# LAUREL LAKE VILLAS

## HUDSON, OHIO

**AHBR DESIGN REVIEW**  
**MAY 27TH, 2026**

# STAFF COMMENTS 2026

# BRANDYWINE, VILLA 3 – DESIGN OPTIONS

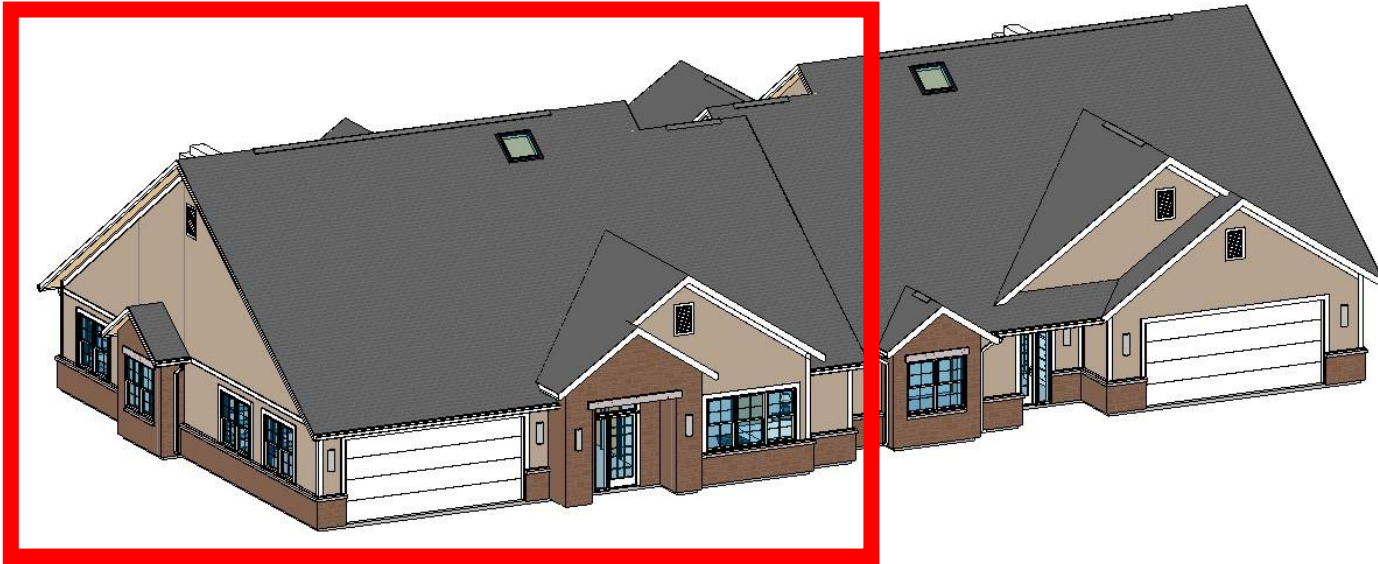
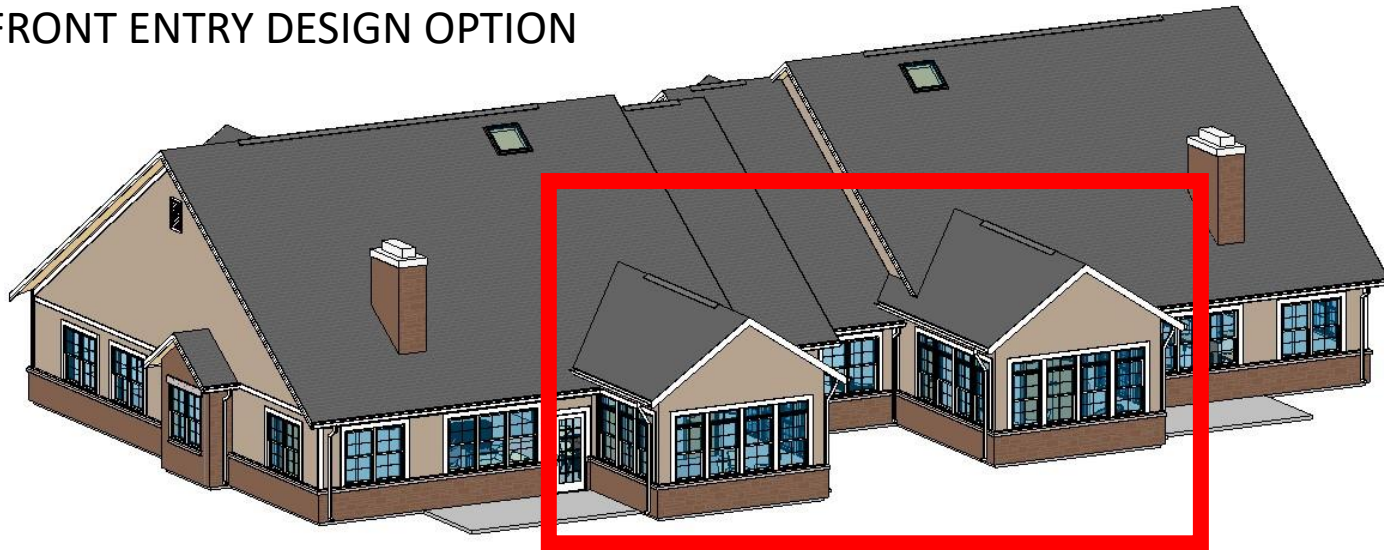
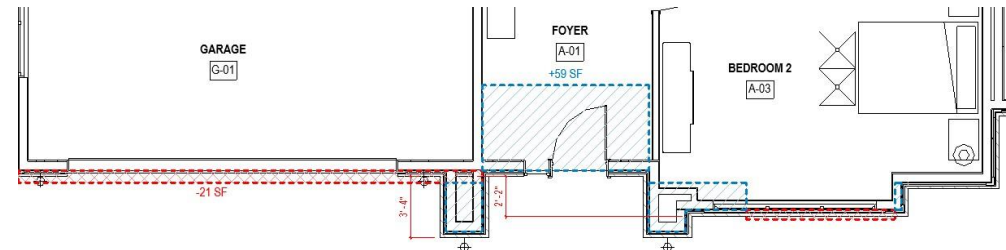
1. Section IV-3 (b)(3) – Forward facing garages.
2. Section IV-3 (b)(2) – Front Faceoff main body is 18” in front of all wings.
3. Section IV-3(g)(2) – 5’ projections treated as wings
4. Section III-1(d)(5) – Fenestration every 12’
5. Section IV-3(c) – Roof to be same shape as main body.
6. Section III-1(g)(3) – Sunroom foundation material.
7. Window trim – Consistent on all elevations.

1. Section IV-3 (b)(3) – Forward facing garages.
2. Section IV-3 (b)(2) – Front Faceoff main body is 18” in front of all wings.
3. Section III-1(d)(5) – Fenestration every 12’
4. Section IV-3(c) – Roof to be same shape as main body.
5. Section III-1(g)(3) – Sunroom foundation material.
6. Window trim – Consistent on all elevations.

# BRANDYWINE, VILLA 3 – REVISED ELEVATIONS

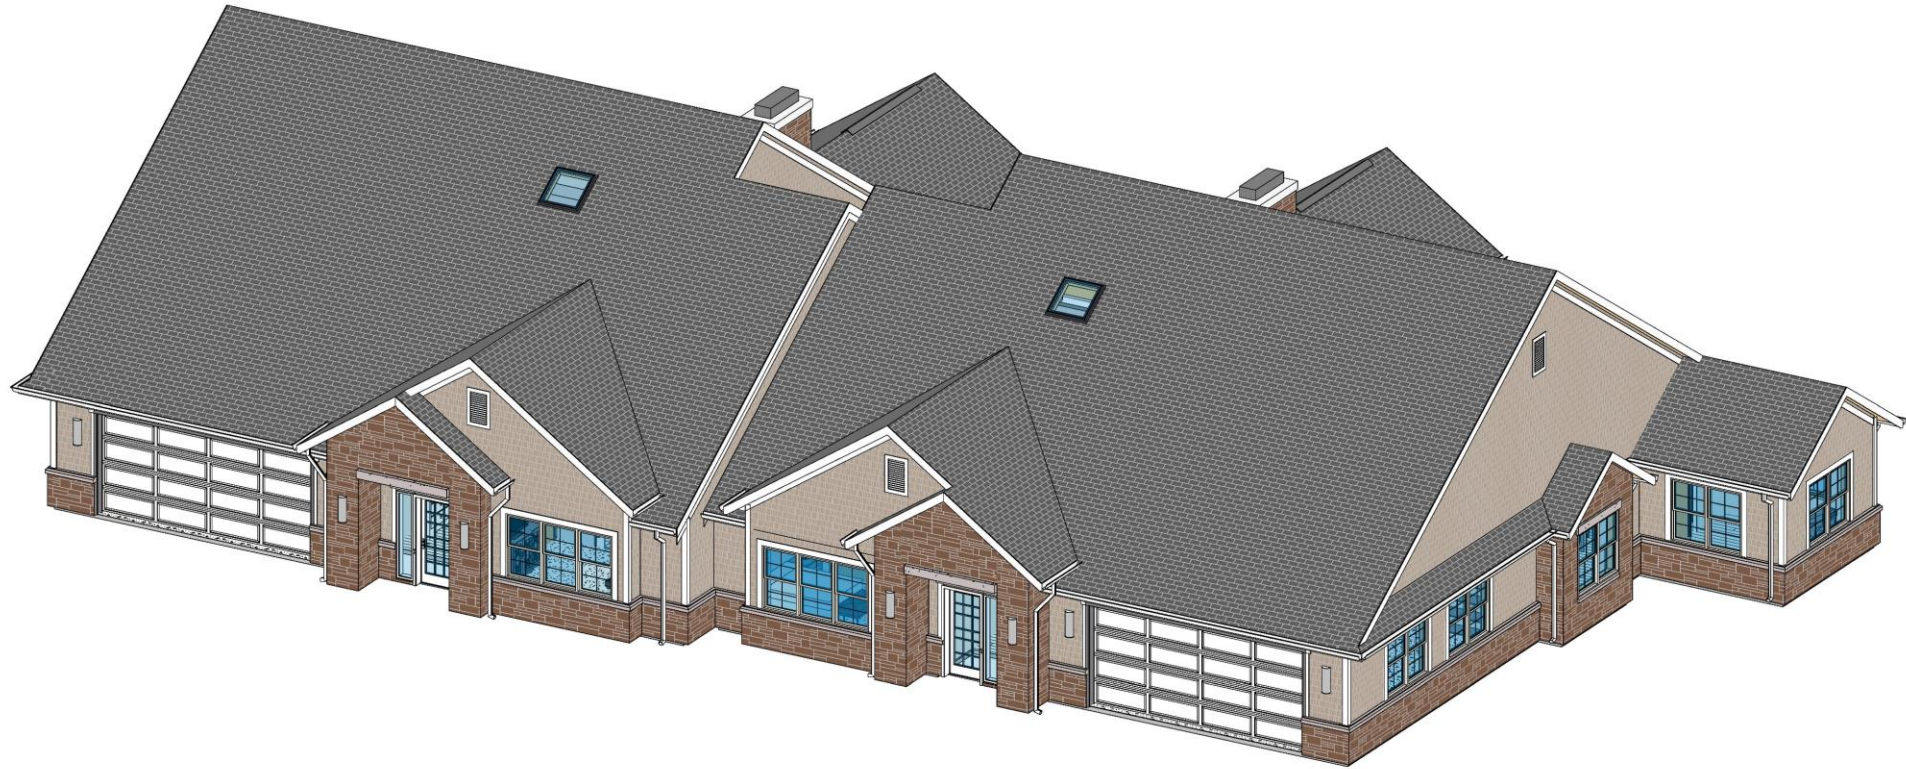
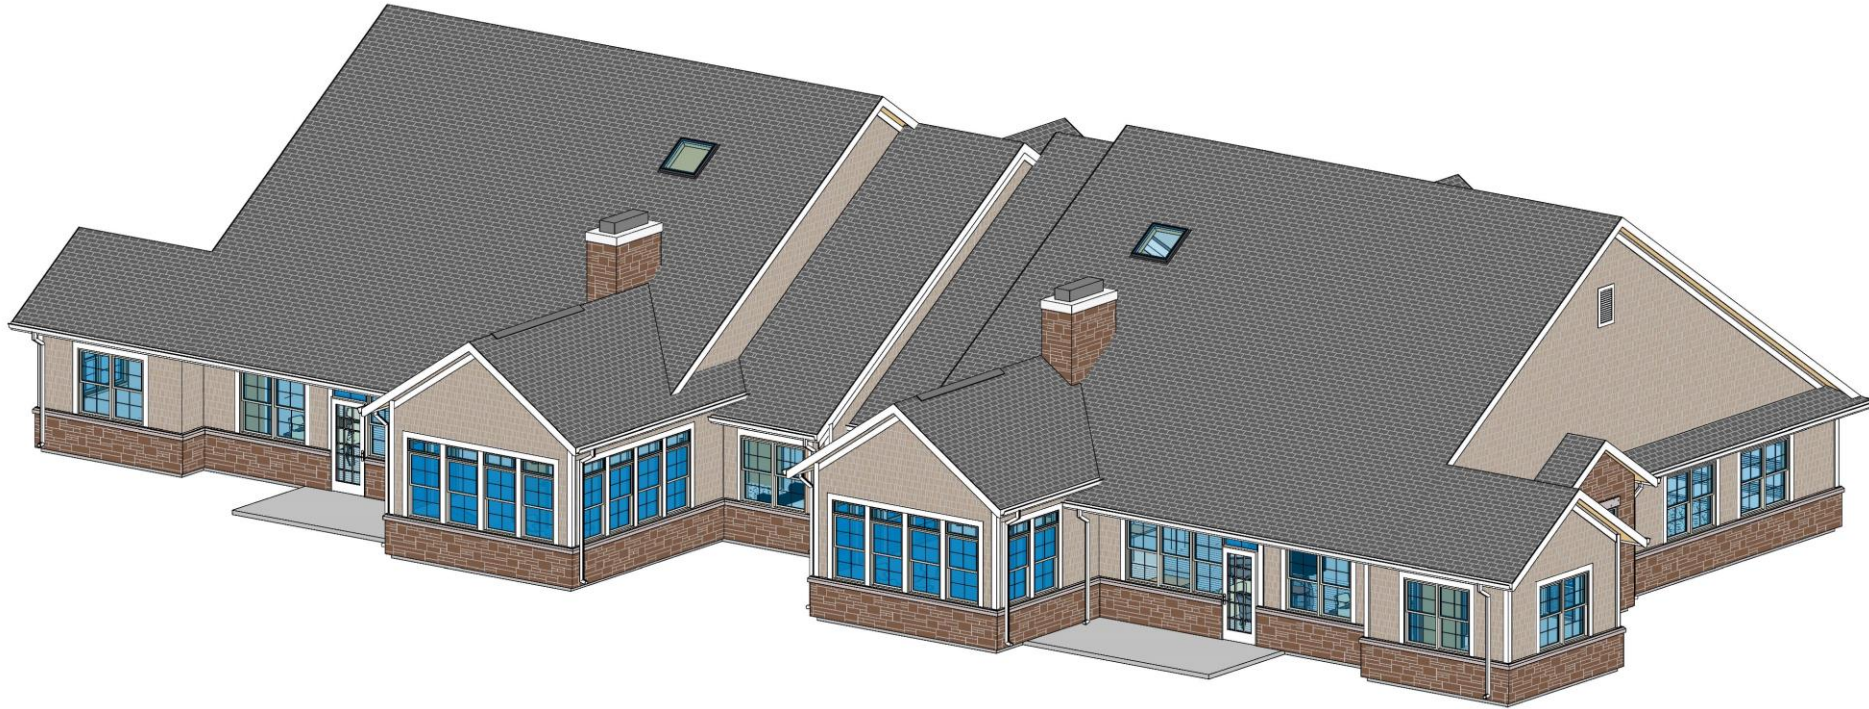
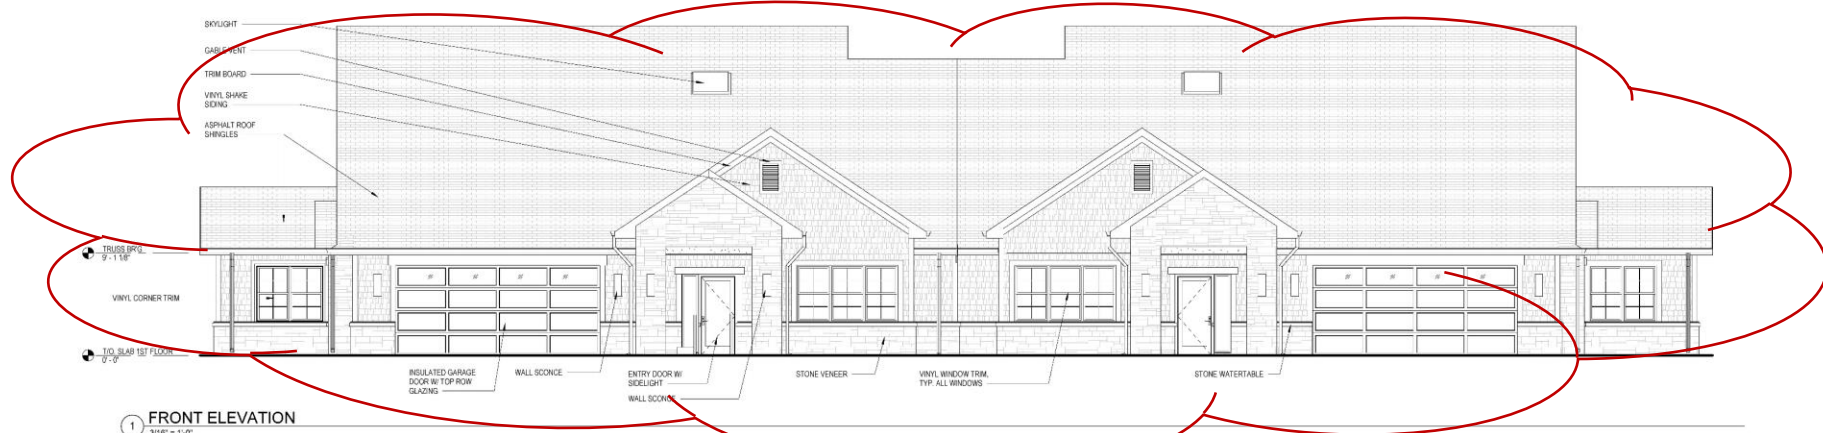
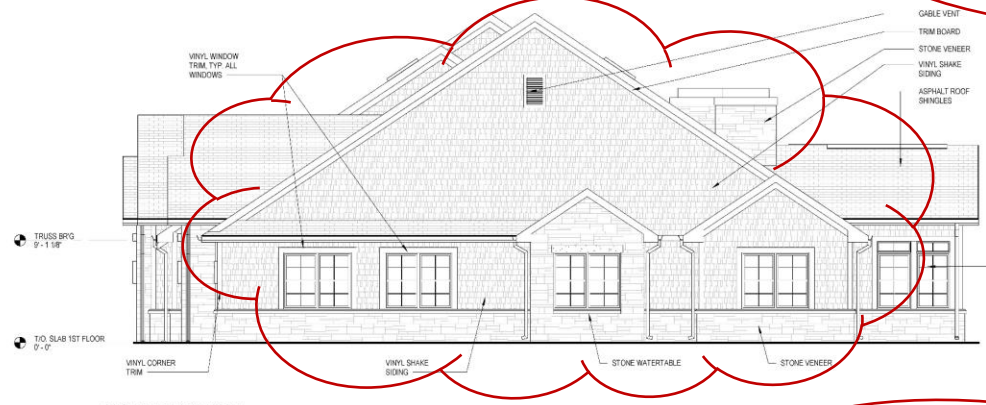
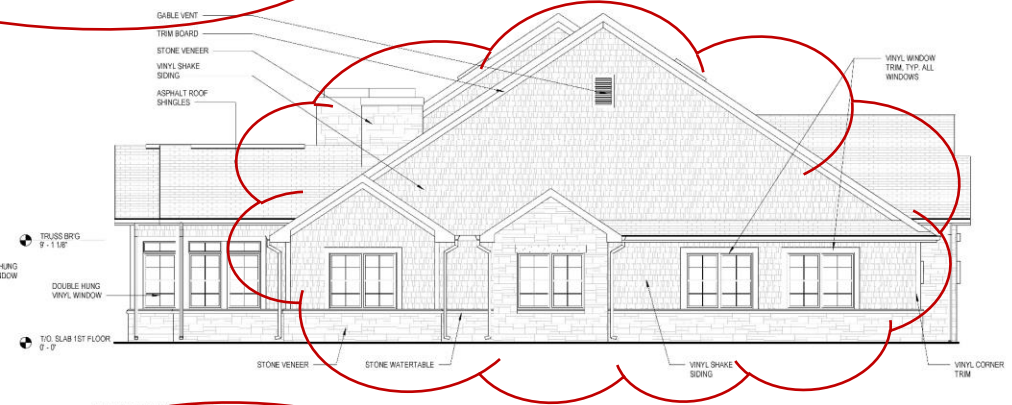
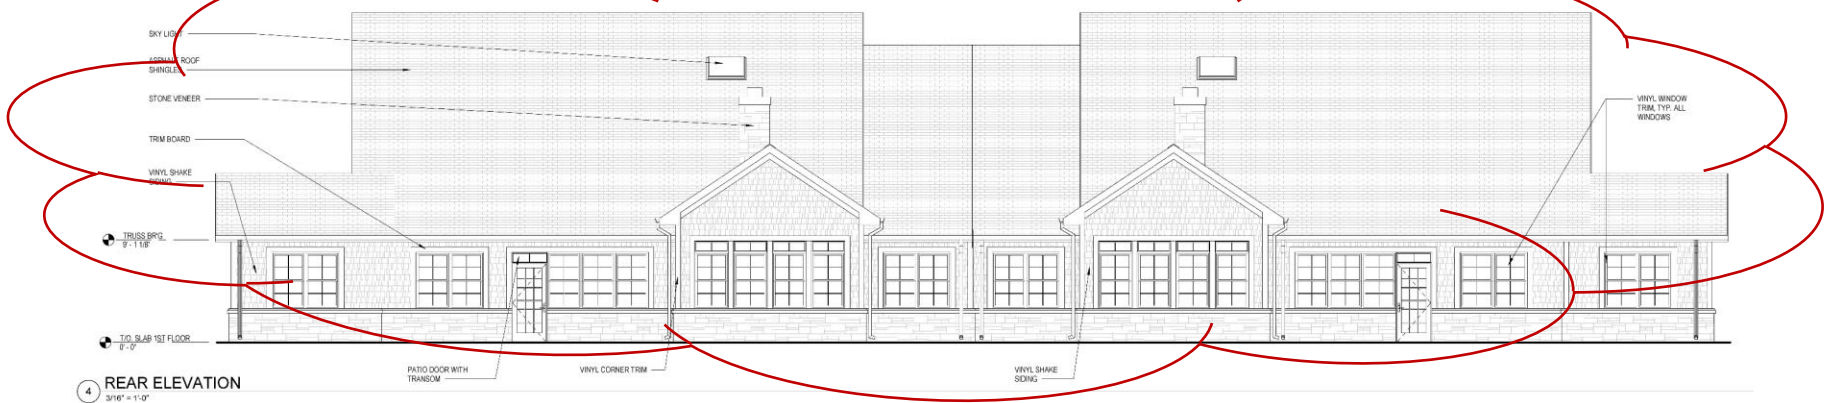
1. Section IV-3 (b)(3) – Forward facing garages.
2. Section IV-3 (b)(2) – Front Faceoff main body is 18” in front of all wings.
3. Section IV-3(g)(2) – 5’ projections treated as wings
4. Section III-1(d)(5) – Fenestration every 12’
5. Section IV-3(c) – Roof to be same shape as main body.
6. Section III-1(g)(3) – Sunroom foundation material.
7. Window trim – Consistent on all elevations.
